**SUBMITTAL OF HANFORD FACILITY RESOURCE CONSERVATION AND RECOVERY  
ACT PERMIT MODIFICATION NOTIFICATION FORM 24590-LAB-PCN-ENV-19-003**

Hanford Facility RCRA Permit Modification Notification  
Form 24590-LAB-PCN-ENV-19-003

**Hanford Facility RCRA Permit Modification Notification Form**  
**Part III, Operating Unit Group 10**  
**Waste Treatment and Immobilization Plant**

Page 2 of 2: Hanford Facility RCRA Permit, Part III, Operating Unit 10, Waste Treatment and Immobilization Plant  
This modification is to update a Lab facility Process Flow Diagram and ten P&IDs in Appendix 11.1 and 11.2 of the DWP Permit

**P&ID - LAB RADIOACTIVE LIQUID WASTE DISPOSAL SYSTEM C3 COLLECTION AND TRANSFER RLD-VSL-00164**

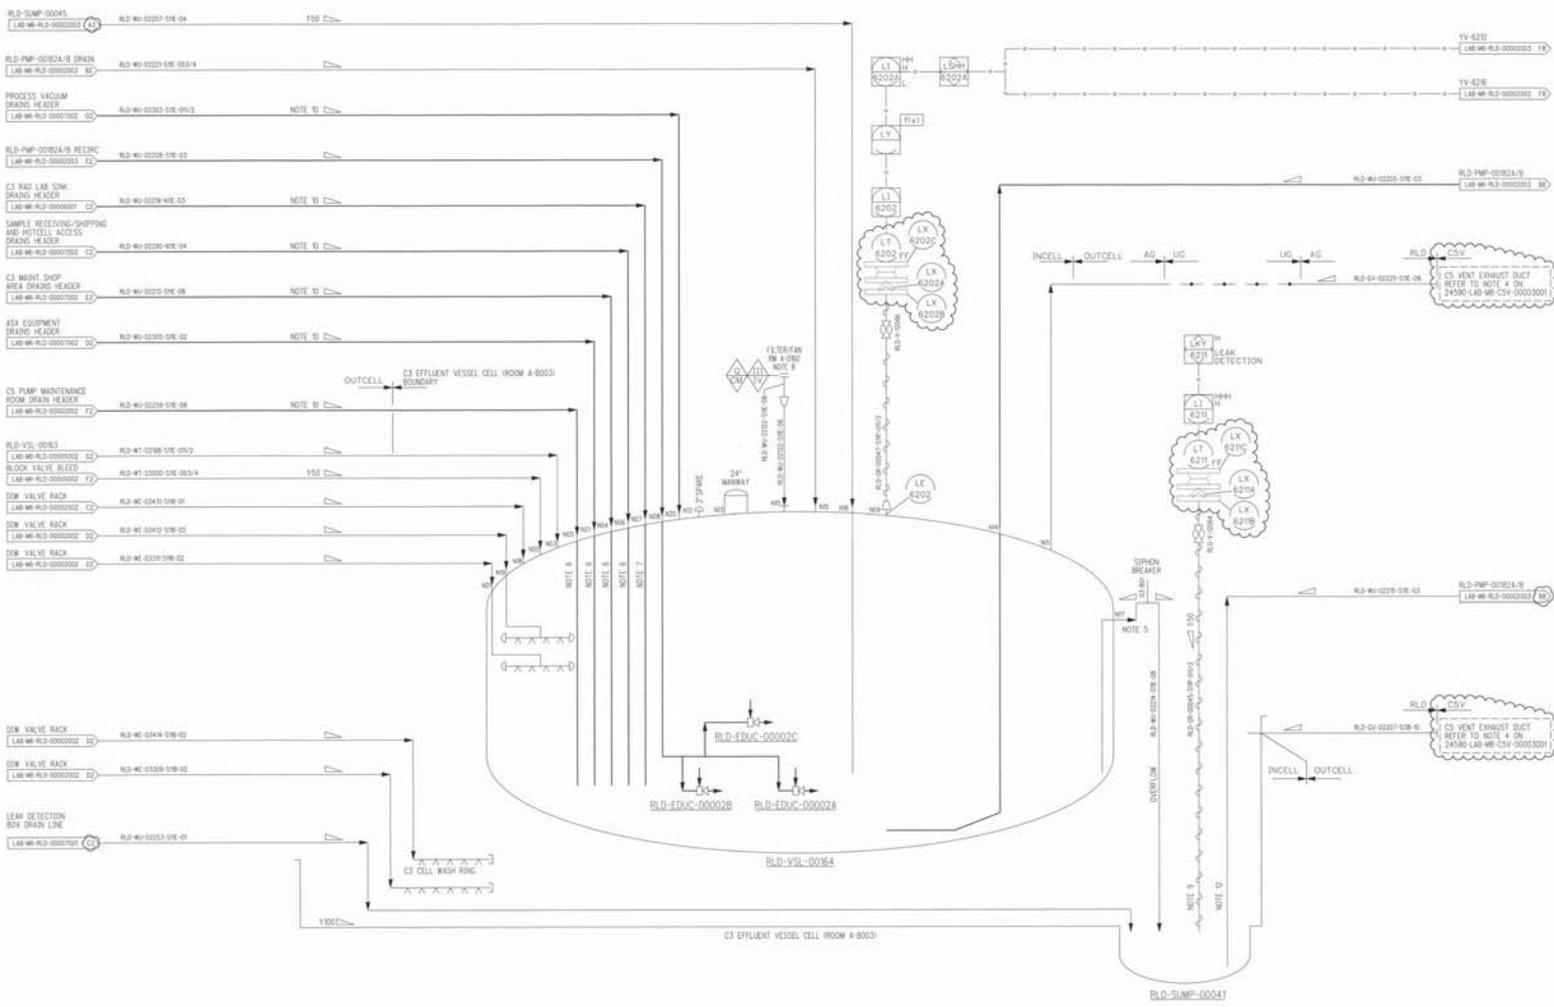
- Note 5: The maximum elevation difference between the inside bottom of the vessel and the inside bottom of the overflow line (at its highest point) shall be 6.84 ft. to yield the maximum operating volume (MOV) of 2740 gal. Moreover, piping beyond the high point shall be free draining with no pockets to the vessel cell.
- Note 14: Revision 2: Incorporated 24590-LAB-M6N-M80T-00008, 24590-LAB-M6N-RLD-00098, 24590-WTP-M6N-50-00073, and 24590-WTP-EIE-J-16-0001, Rev. 0. 24590-WTP-EIE-J-16-0001 incorporated by 24590-WTP-M6N-50-00073. Revised Reference 1, off sheet connectors and updated ADR revision number.
- Reference 1 added to support revision outlined in Note 14

24590-LAB-M6-RLD-00006001, Rev. 001, P&ID – Lab Radioactive Liquid Waste Disposal System C3 Rad Lab Collection

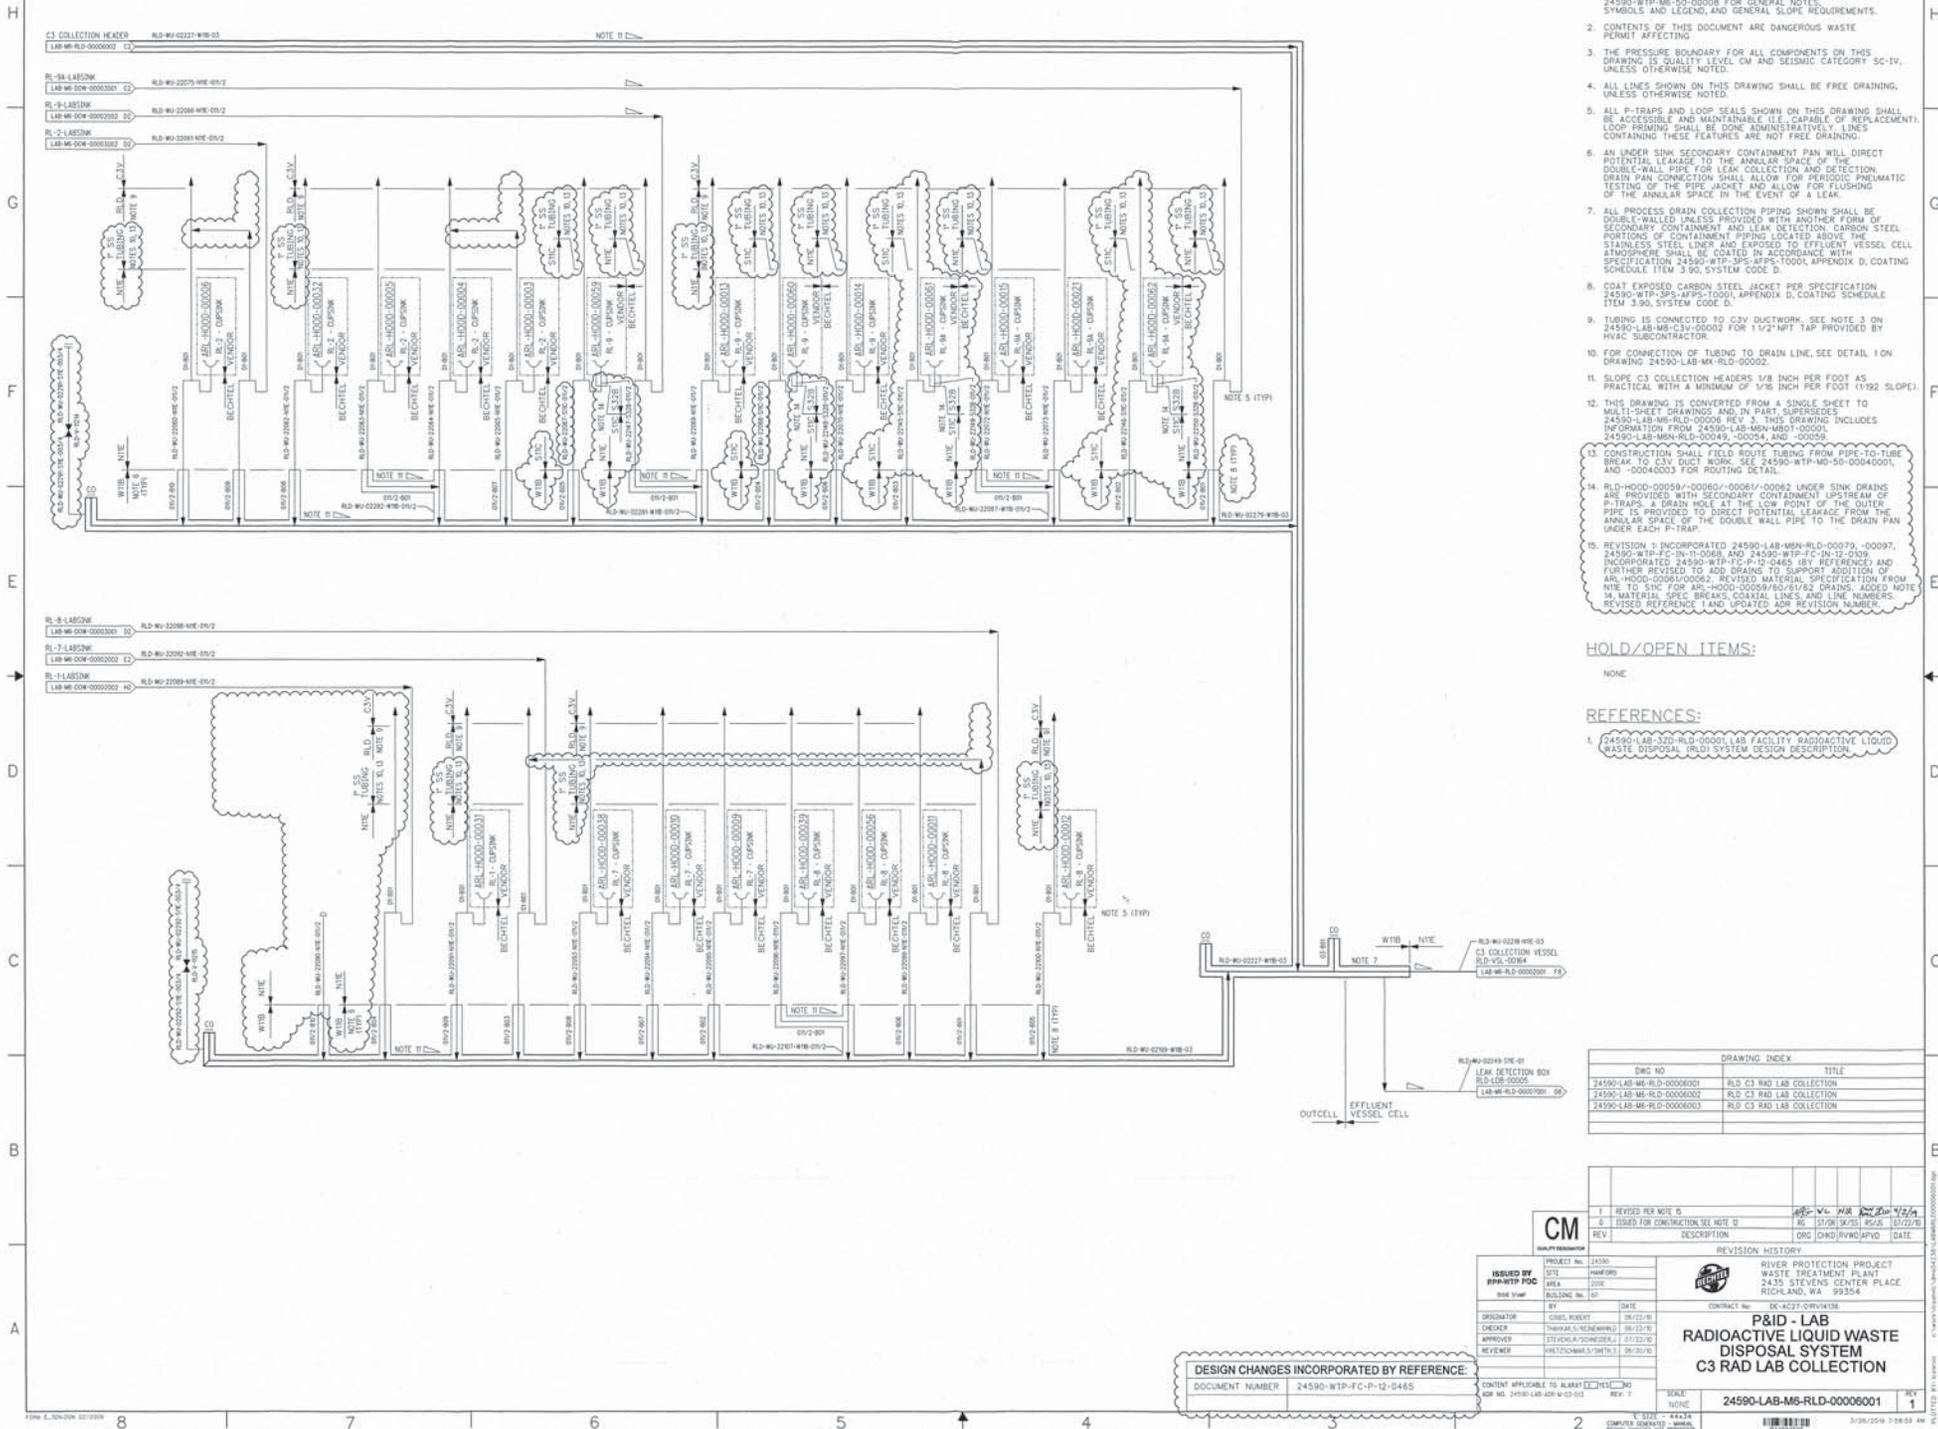
- Note 13: Construction shall field route tubing from pipe-to-tube break to C3V duct work. See 24590-WTP-M0-50-00040001, and -00040003 for routing detail
- Note 14: RLD-HOOD-00059/ -00060/ -00061/ -00062 under sink drains are provided with secondary containment upstream of P-traps. A drain hole at the low point of the outer pipe is provided to direct potential leakage from the annular space of the double wall pipe to the drain pan under each P-trap.
- Note 15: Revision 1: Incorporated 24590-LAB-M6N-RLD-00079, -00097, 24590-WTP-FC-IN-11-0068, and 24590-WTP-FC-IN-12-0109. Incorporated 24590-WTP-FC-P-12-0465 (by reference) and further revised to add drains to support addition of ARL-HOOD-00061/00062. Revised material specification

from N11E to S11C for ARL-HOOD-00059/60/61/62 drains. Added Note 14, revised Reference 1 and updated ADR revision number

- Reference 1 added to support revision outlined in Note 15

24590-LAB-M6-RLD-00006003, Rev. 001, P&ID – Lab Radioactive Liquid Waste Disposal System C3 Rad Lab Collection

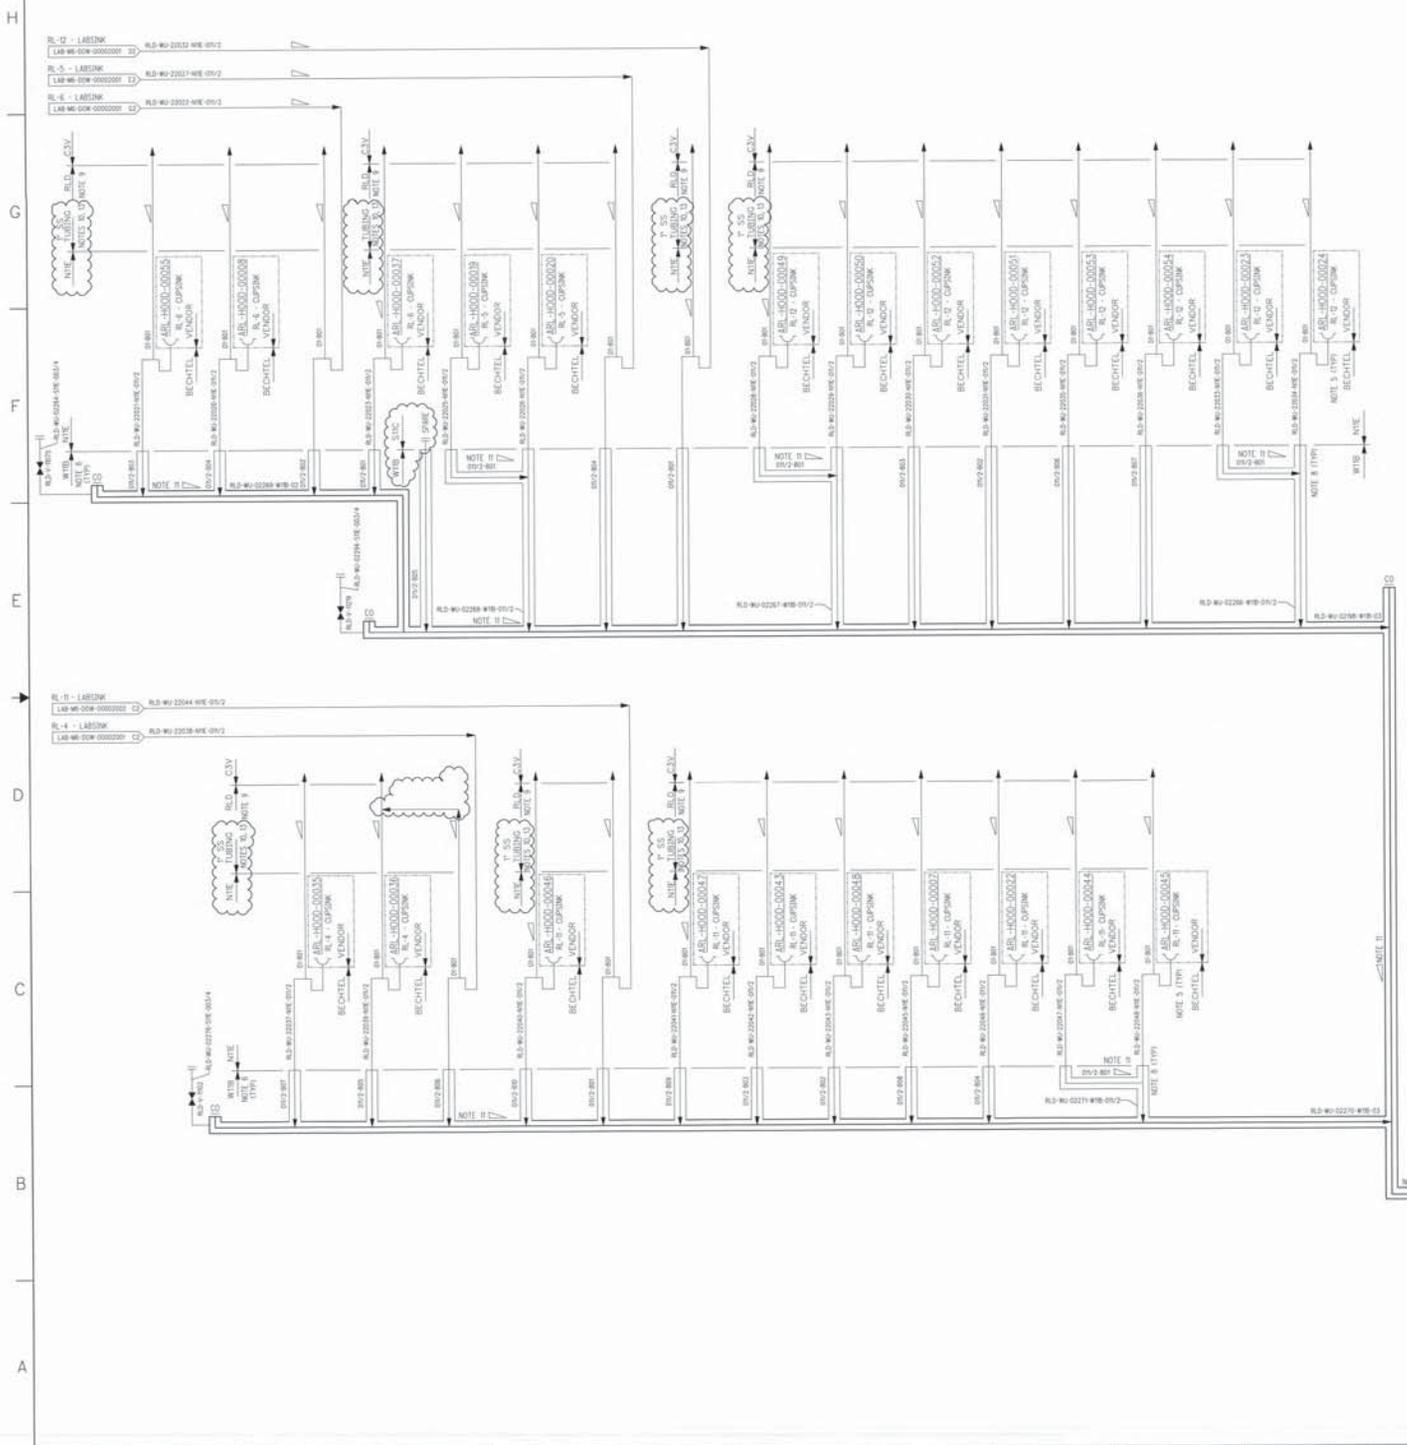
- Note 13: Construction shall field route tubing from pipe-to-tube break to C3V duct work. See 24590-WTP-M0-50-00040002 and -00040003 for routing details
- Note 14: Revision 1: Incorporated 24590-LAB-M6N-RLD-00097, 24590-WTP-FC-IN-12-0109 and 24590-WTP-FC-P-12-0465. Revised Reference 1 and updated ADR Revision number
- Reference 1 added to support revision outlined in Note 14

**P&ID - LAB RADIOACTIVE LIQUID WASTE DISPOSAL SYSTEM C3 LEAK DETECTION BOXES**

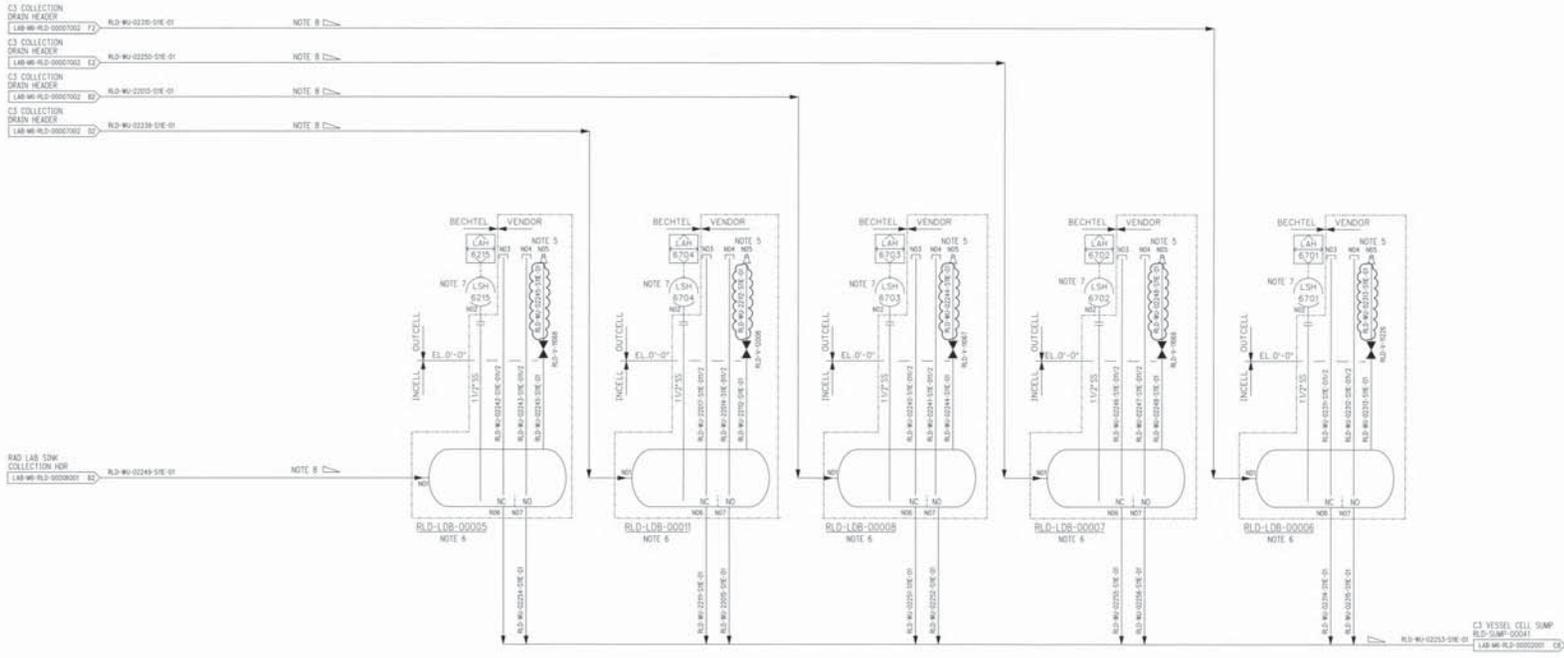
- Note 10: Revision 1: Incorporated 24590-LAB-M6N-RLD-00095. Revised Reference 1, added line numbers, and updated ADR Revision number.
- Reference 1 added to support revision outlined in Note 10

24590-LAB-M6-RLD-00007002, Rev. 001, P&ID – Lab Radioactive Liquid Waste Disposal System C3 Collection Drain Header

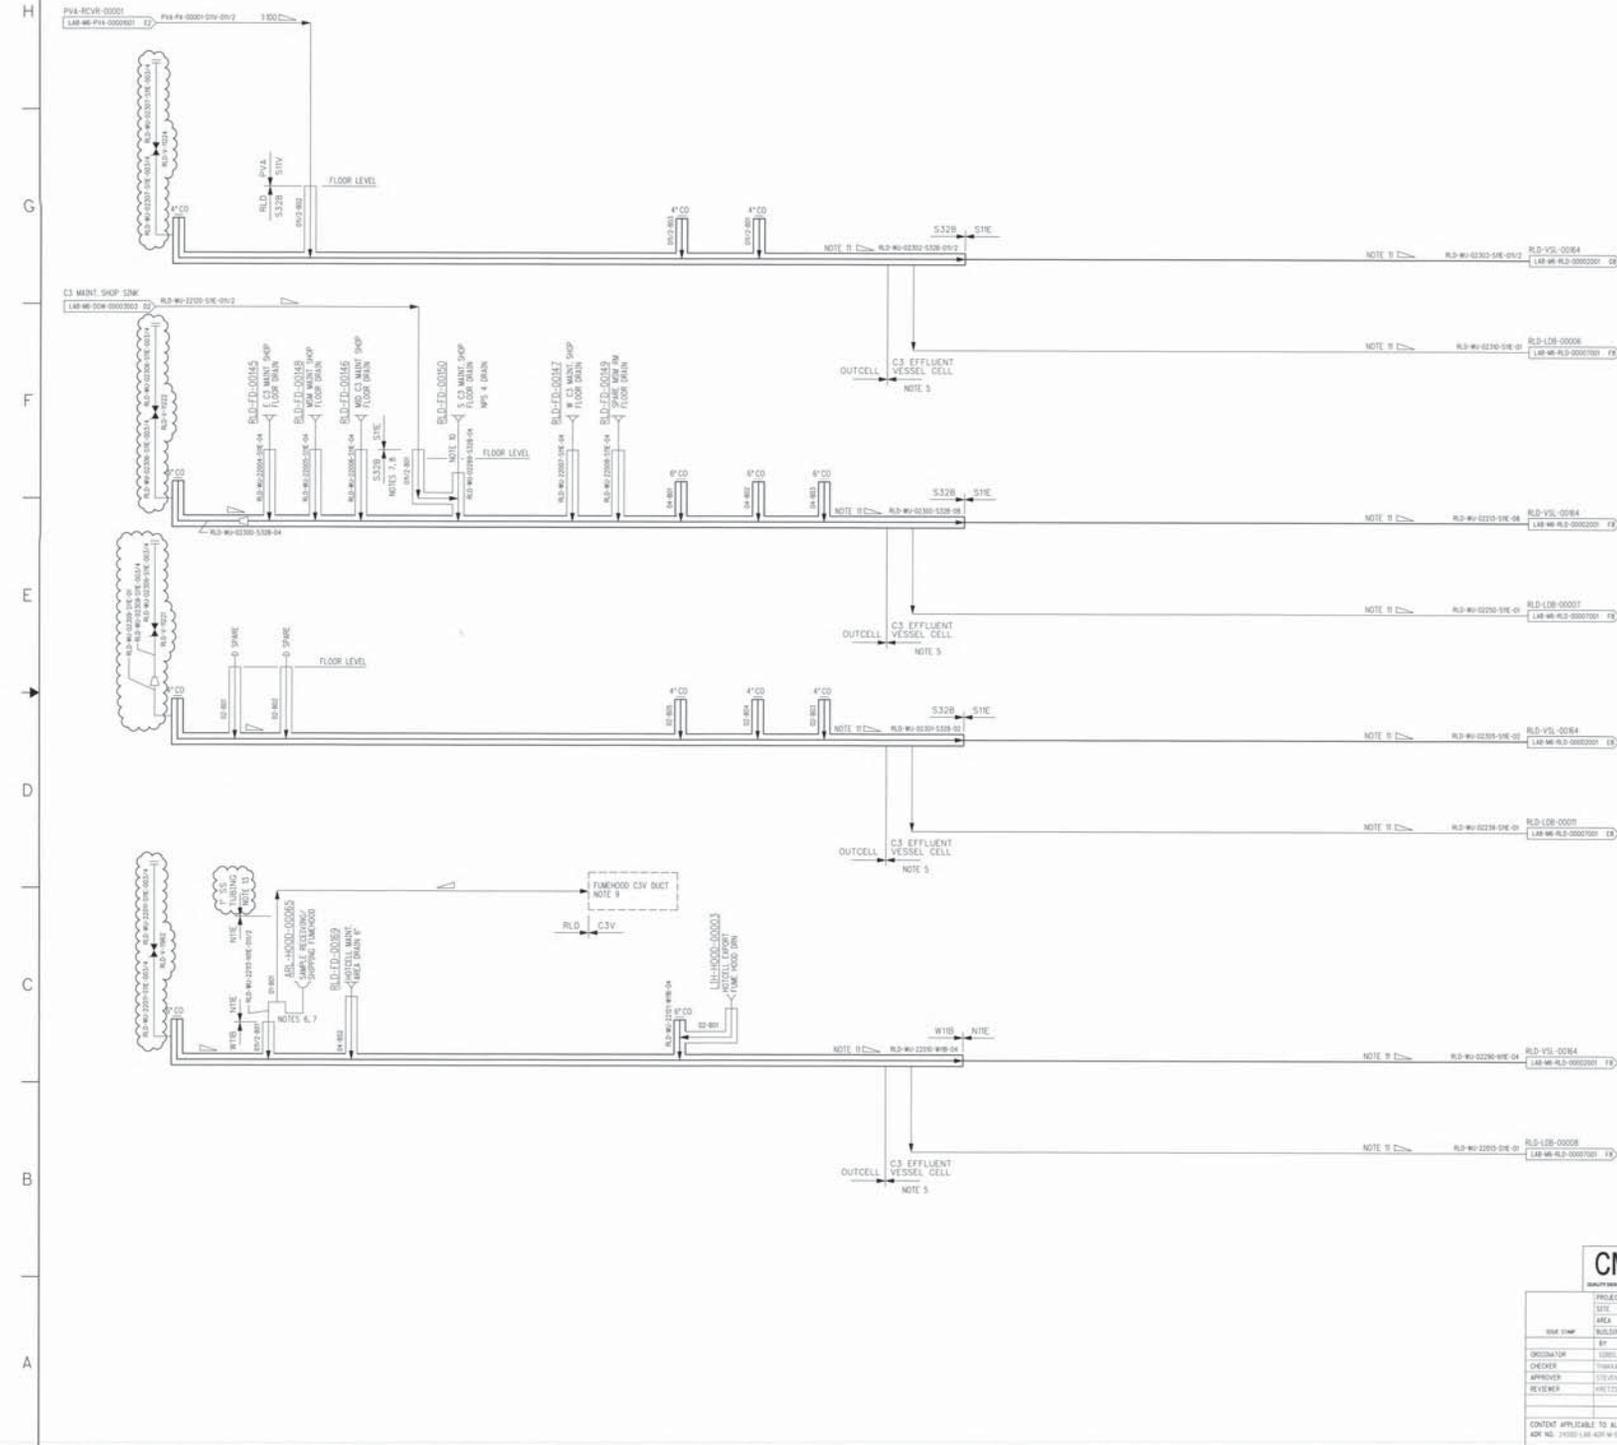
- Note 13: Construction shall field route tubing from pipe-to-tube break to C3V duct work. See 24590-WTP-M0-50-00040002 for routing details
- Note 14: Revision 1: Incorporated 24590-LAB-M6N-RLD-00097. Revised Reference 1, added line numbers, and updated ADR Revision number.
- Reference 1 added to support revision outlined in Note 14
